TELEDYNE CONTINENTAL[®] AIRCRAFT ENGINE

SERVICE BULLETIN

SB01-5

SUBJECT: STARTER ADAPTER BEVEL GEAR INSPECTION

FIGURE 1
Exploded View P/N 646220A38 Starter Adapter

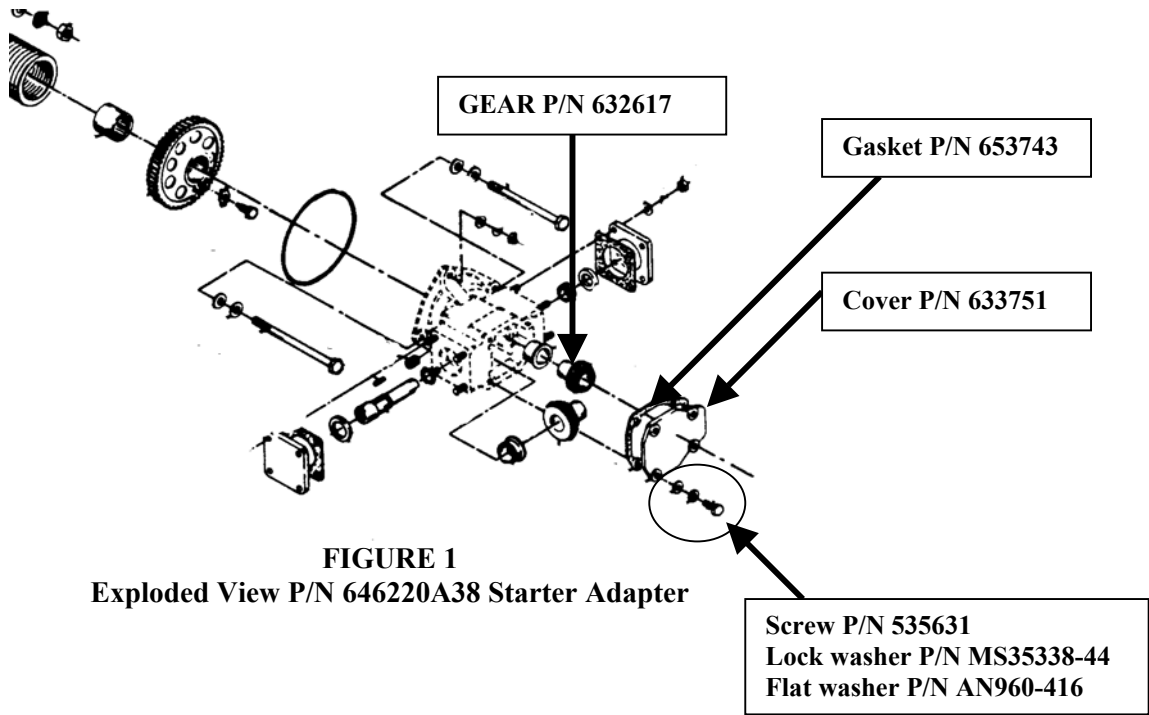
For affected engines listed in Table 1 and engines with field repaired or overhauled starter adapter P/N 646220A38 that utilized bevel gear P/N 632617; within the next 25 hours of engine operation perform a visual inspection of bevel gear P/N 632617 for spalling as outline below. Repeat this inspection at 50 hour intervals until starter adapter P/N 646220A38 is replaced with current production starter adapter P/N 646220A54.

1. In accordance with the aircraft manufacturer's instruction gain access to the engine and specifically the engine accessory area.
2. Referring to Figure 1, remove the "T" drive cover plate P/N 633751, by removing 4 each screws, 4 each lock washers and 4 each flat washers. Remove gasket P/N 653743.
3. Visually inspect bevel gear P/N 632617 for indication of gear tooth distress, spalling, broken or chipped gear teeth. Inspect interior of "T" drive housing for gear debris.
4. If visual inspection DOES NOT reveal any damage to bevel gear P/N 632617 and there is no gear debris noted in "T" drive housing interior reinstall cover P/N 633751 using a new gasket P/N 653743 and new lock washers P/N MS35338-44. Torque screws P/N 535631 to 75 to 85 inch pounds.
On completion of the above inspection, complete the owner notification form and mail it or fax it to TCM. ①

5. If visual inspection reveals damage to bevel gear P/N 632617 or if there is debris in the interior of the "T" drive housing the starter adapter assembly will have to be removed for repair or replacement. Contact TCM Technical Service Support at 1-888-826-5465

FIGURE 2
Exploded View P/N 646220A54 Starter Adapter

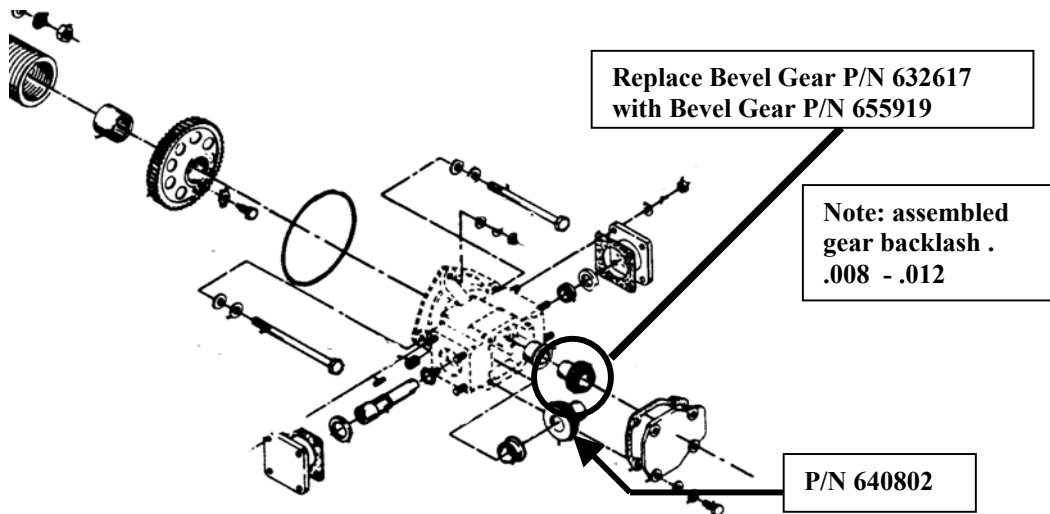
Bevel gear P/N 632617 is being replaced with bevel gear P/N 655919. Bevel gear P/N 655919 will be available the end of September 2001. TCM will, on an exchange basis, replace all starter adapters affected by this Service Bulletin once gear P/N 655919 is available. In the event an affected P/N 646220A38 starter adapter assembly requires replacement prior to bevel gear P/N 655919 being available, TCM will as an interim action supply a P/N 646220A38 starter adapter assembly.

Starter adapters P/N 646220A38 will be replaced with starter adapter P/N 646220A54 when they become available. Service spare bevel gear P/N 632617 will be replaced by bevel P/N 655919. During field repair of overhaul bevel gear P/N 655919 must be used with gear P/N 640802. Refer to Figure 2.
